**RE: Oakland Ridge Subdivision
Grading Plan and Drainage Report
Stamp Date: 6/27/17
Hydrology File: C18D085**

*Oakland Ridge Subdivision
Drainage Management Plan*

**Re: Oakland Ridge Subdivision
Engineers stamp date 6-27-17 (C18 /D085)**

**RE: Oakland Ridge Subdivision
Grading Plan and Drainage Report
Stamp Date: 5/19/17
Hydrology File: C18D085**

FIGURE 4
OAKLAND RIDGE SUBDIVISION
SUB-BASIN BOUNDARY EXHIBIT

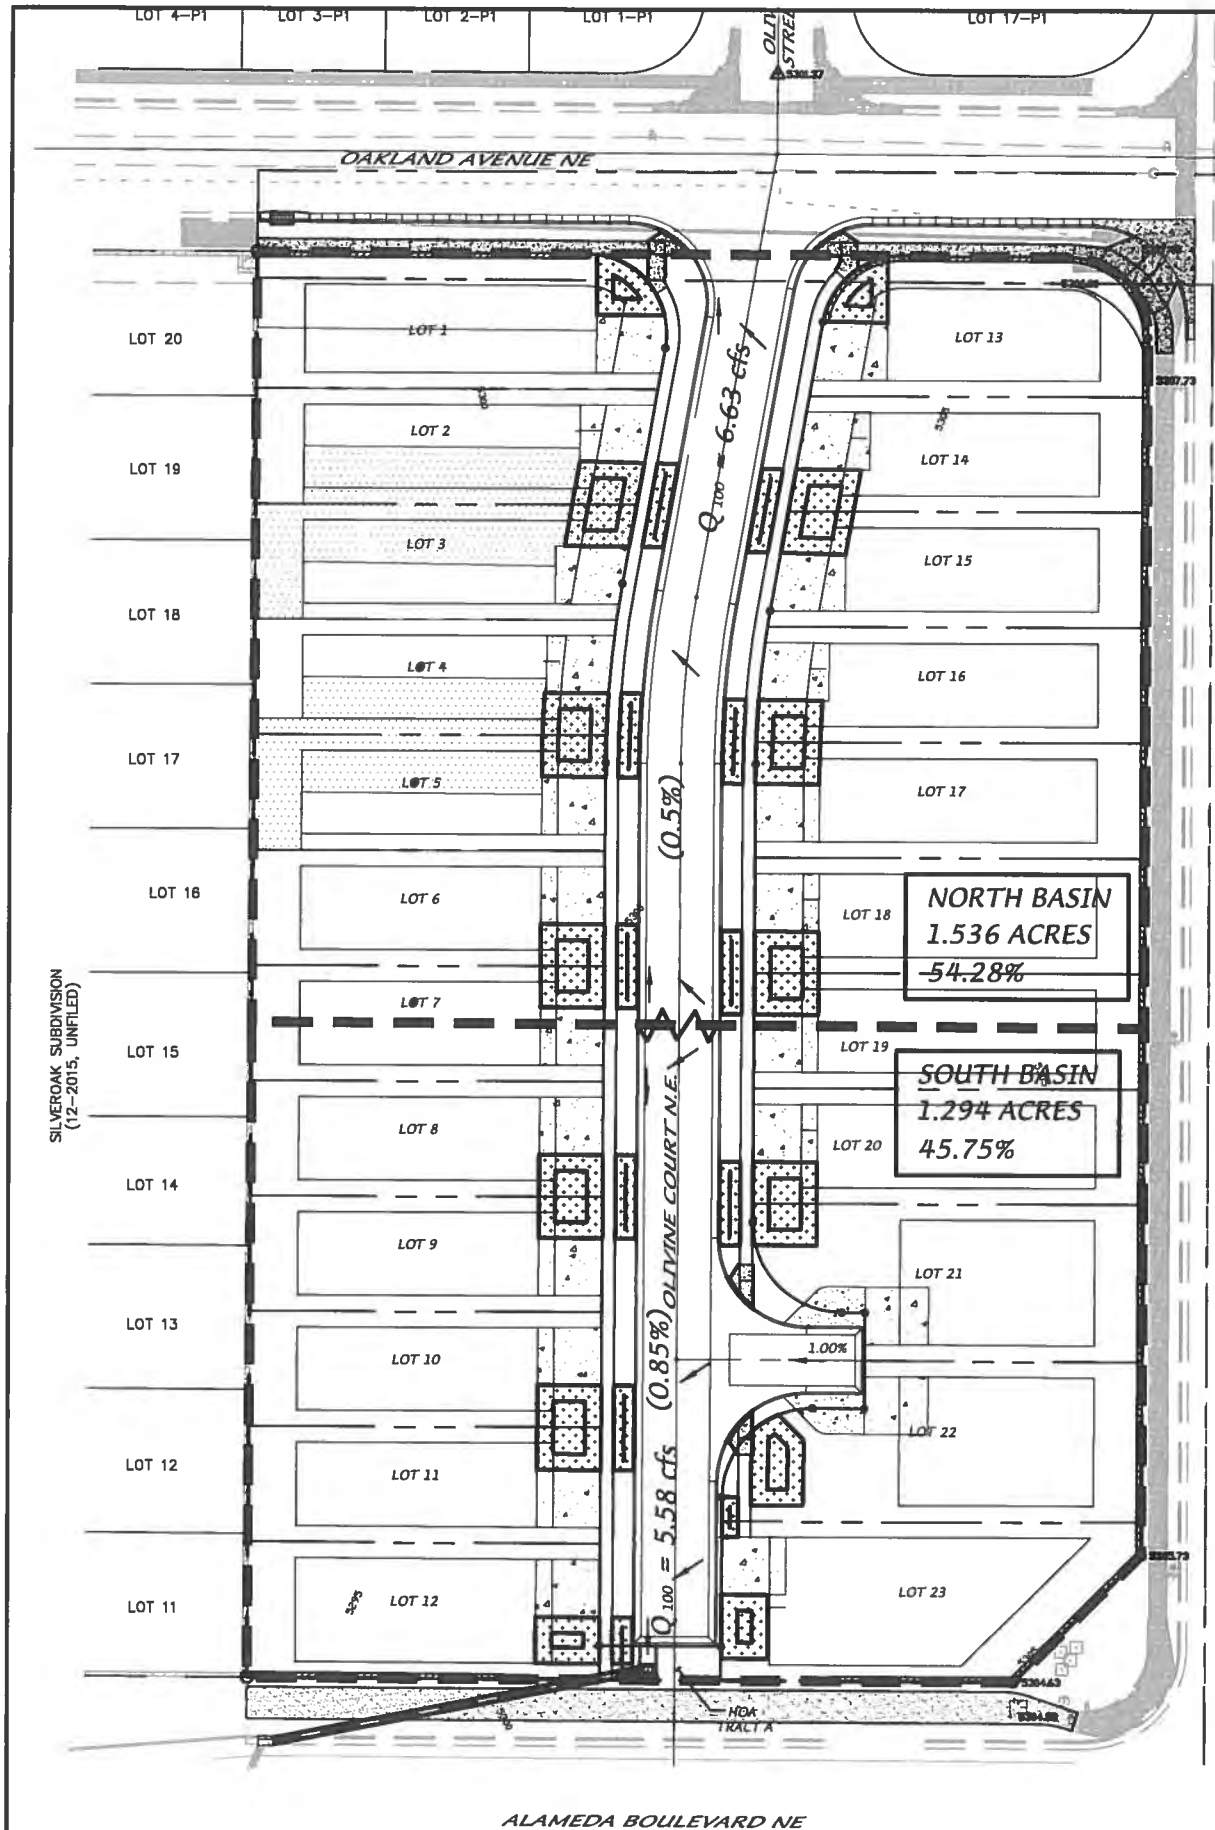
5. Please update Figure 4 as outlined above. Also please state the acreage of the North basin and the South basin.
6. Please update Figure 5. This should reflect the new basins, so Lot 6 & 7 information should be moved from the South basin to the North basin. Also Lot 18 & 19 information should be moved from the South basin to the North basin.

Oakland Ridge Subdivision
Typical Lot Drainage / First Flush Pond Interface

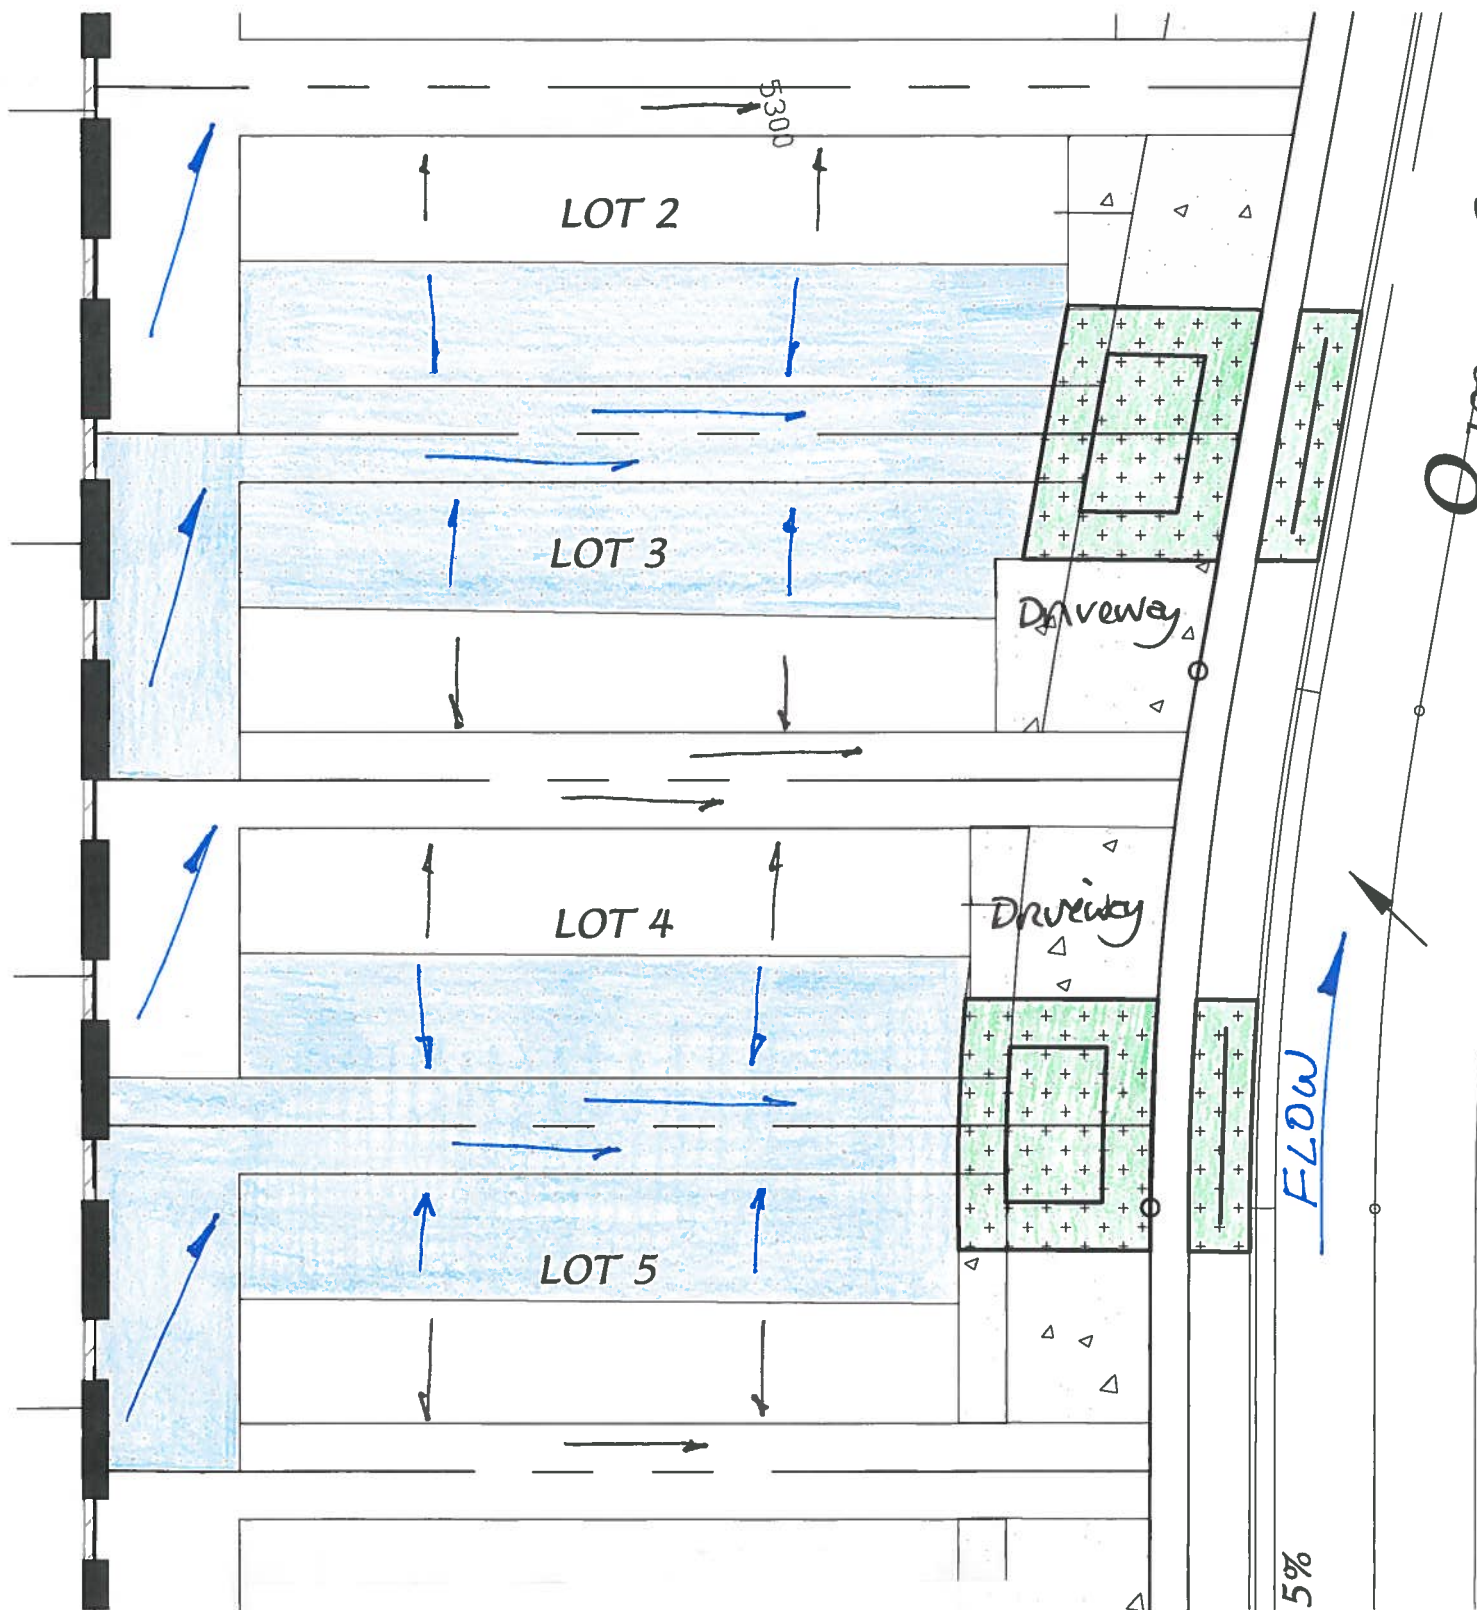
6. Please clarify the Typical Lot Grading Scheme. It appears that the back lot drainage will just travel either to the north or south depending on the grading without being directed to the first flush ponds.

7. It appears that the first flush ponds will not collect the majority of the lot runoff as designed. Please show that each first flush basin is designed for its drainage basin. Pond location or another layout may be necessary.

6. *Yes, that is correct, the entire site does not drain to the first flush pond. The driveways do not allow this situation. The roof and part of the sideyards and back yards only as shown. Refer to exhibit in Appendix.*

7. *Typical detail is shown in the Appendix as mentioned in #6. The front yard ponds and curb side ponds are designed to capture as much runoff as possible.*

PROJECT Oakland Ridge Subd.
SUBJECT Hydrology - Temp. Pond
BY DWG DATE 6-26-17
CHECKED _____ DATE _____
SHEET _____ OF _____

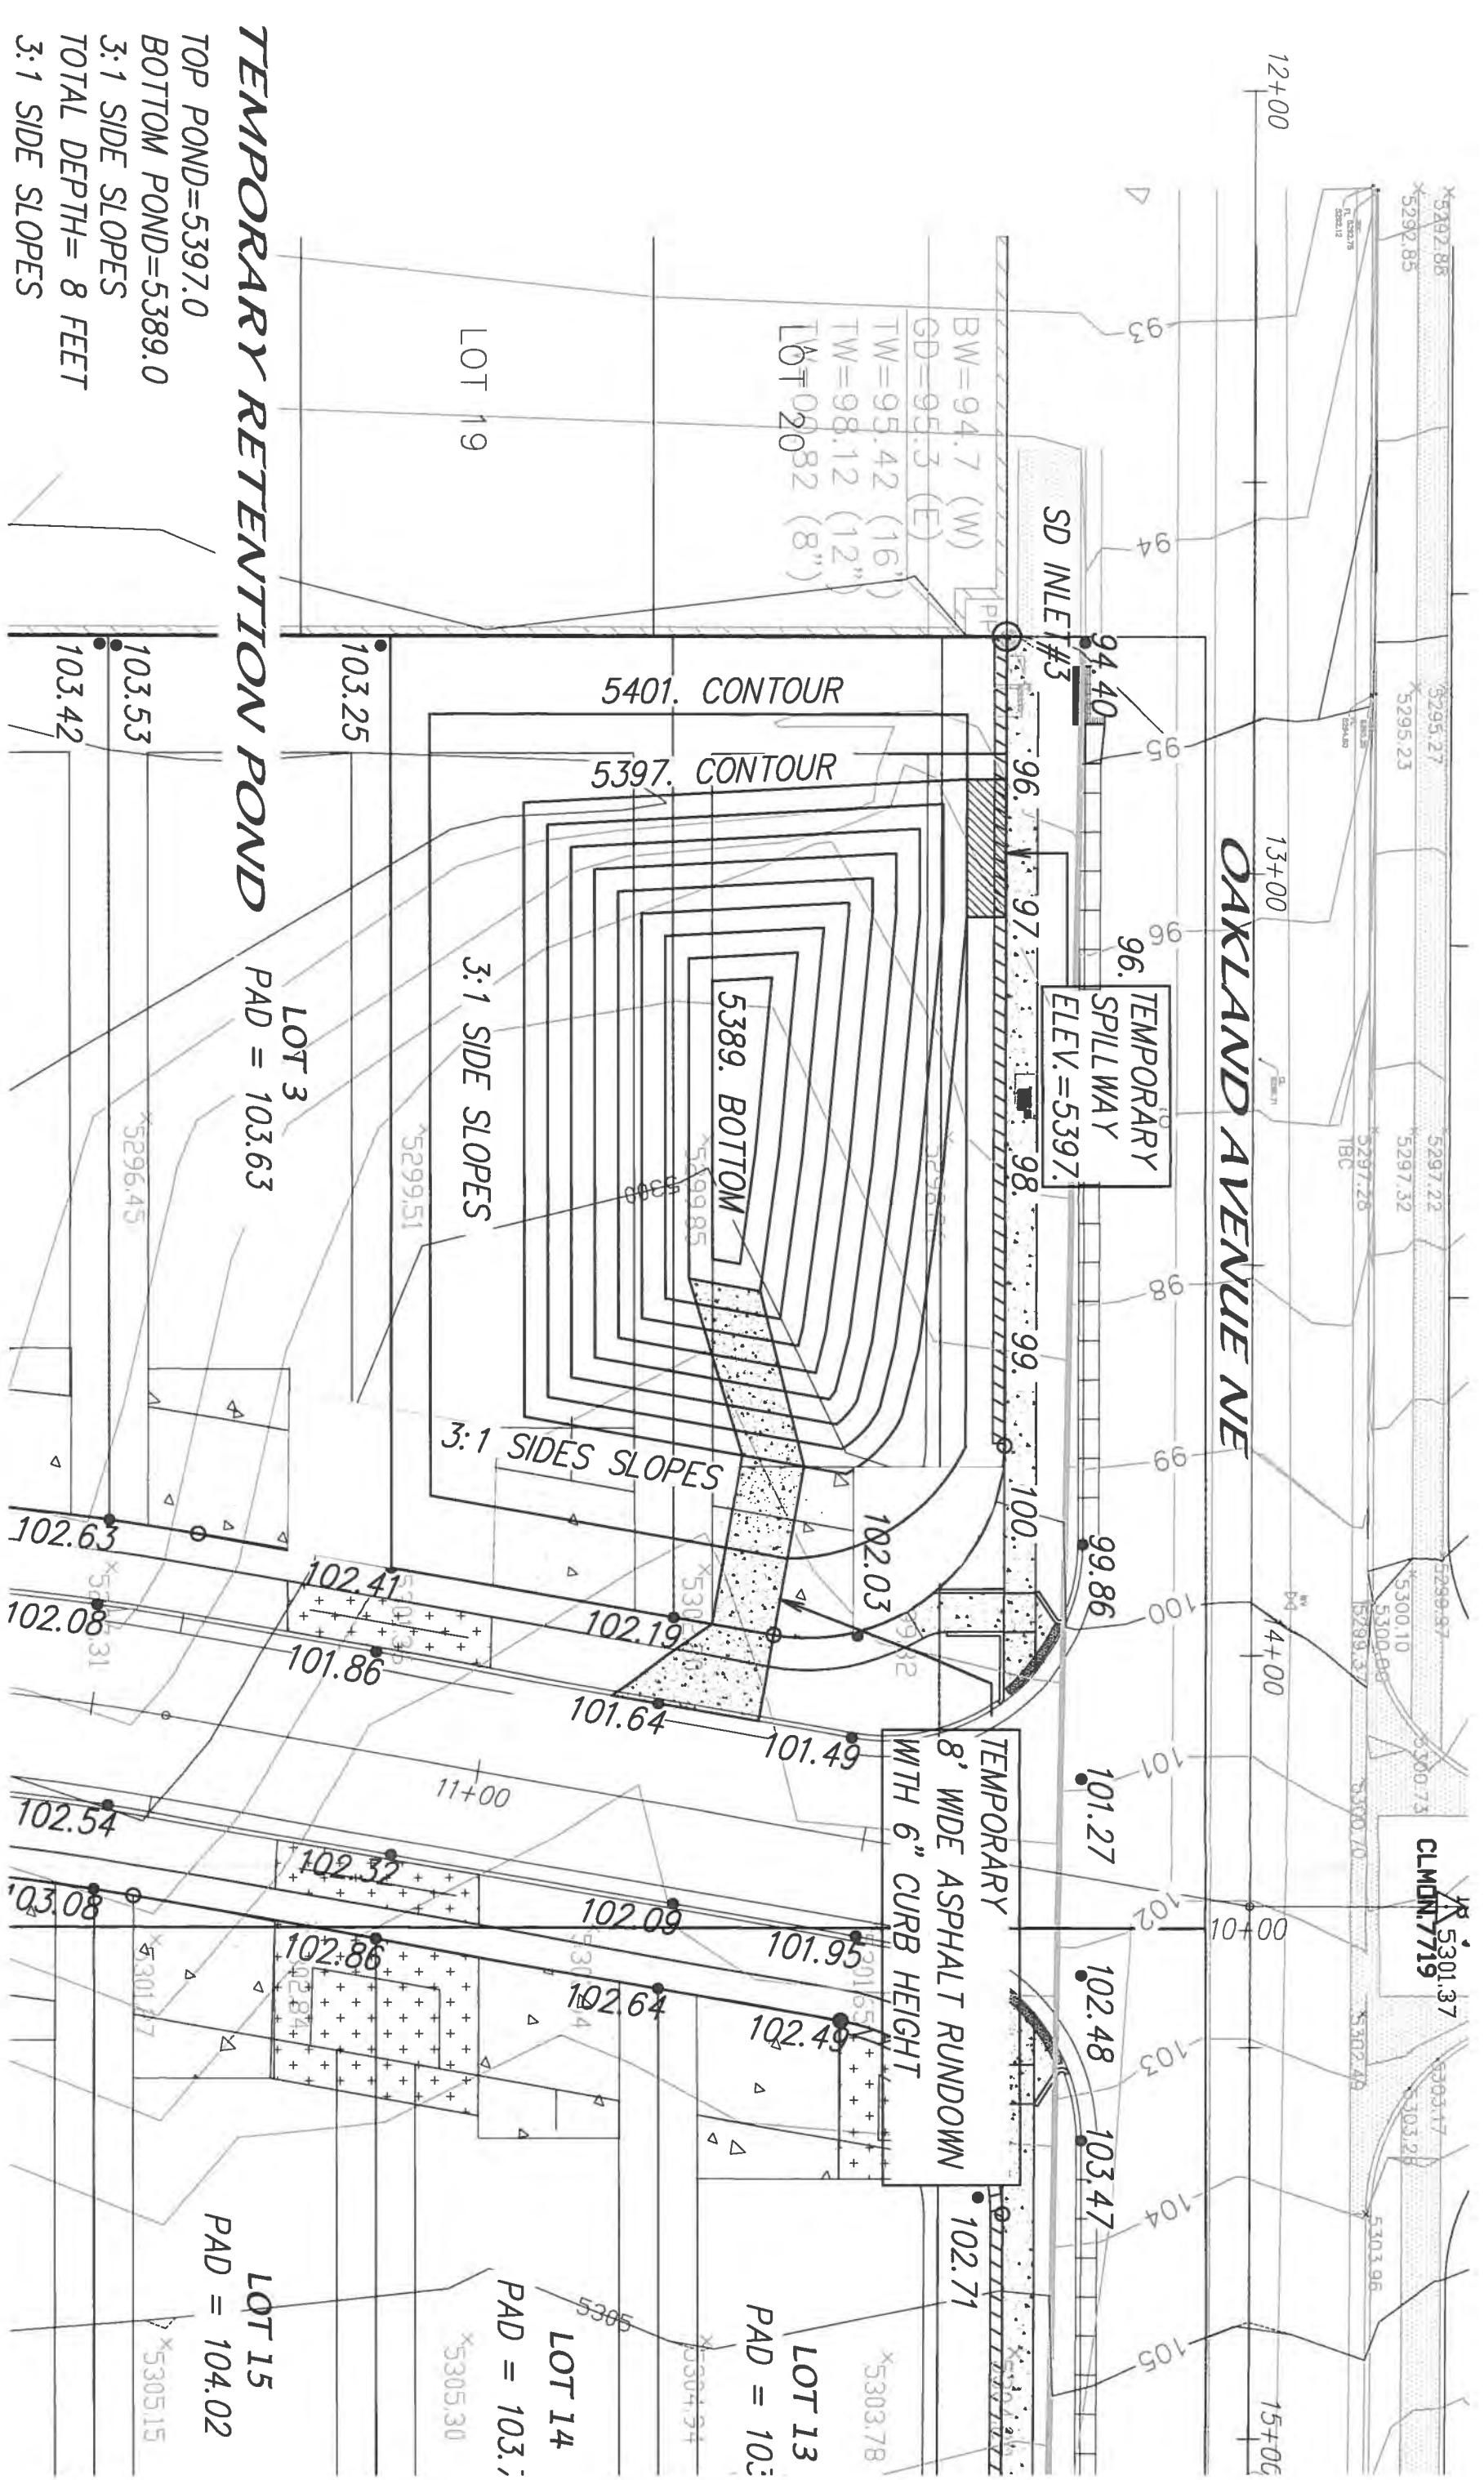
2. Please note that the proposed 30-in storm pipe on Oakland Ave. which will tie into the above mentioned existing manhole and storm sewer is currently at best only about 20% constructed. This has a completion date in August and accepted by the City two or three months after the completion date. Depending on the quickness of this project, a temporary retention pond may be needed until the storm sewer system is accepted by the City.

1. Text has been added.
2. A temporary retention pond has been sized and is shown in the drainage report.
3. If this storm drain system in Oakland is supposed to accept flows from this project site, as you mentioned in #1, #2 and #3, it should have already been designed by the Engineer who designed the storm drain system and to accept flow from Sub Basin 117.2 which includes my project site.
4. I have regraded the entire site at your request, to move the high point 50 feet to the south, to reroute 0.95 cfs to the north for the 100 year storm event.
5. Done
6. Figure 5 has been updated.
7. Done, calculations are the Appendix.
8. Profiling storm pipe is done at DRC. Manning's equation indicates a 24" storm pipe carrying 5.56 cfs at a 10.2% slope is well below top of pipe, therefore HGL in pipe is not an issue.

Since the storm drain system in Oakland Avenue is under construction but not completed yet, a temporary retention pond has been designed as shown in Appendix B.
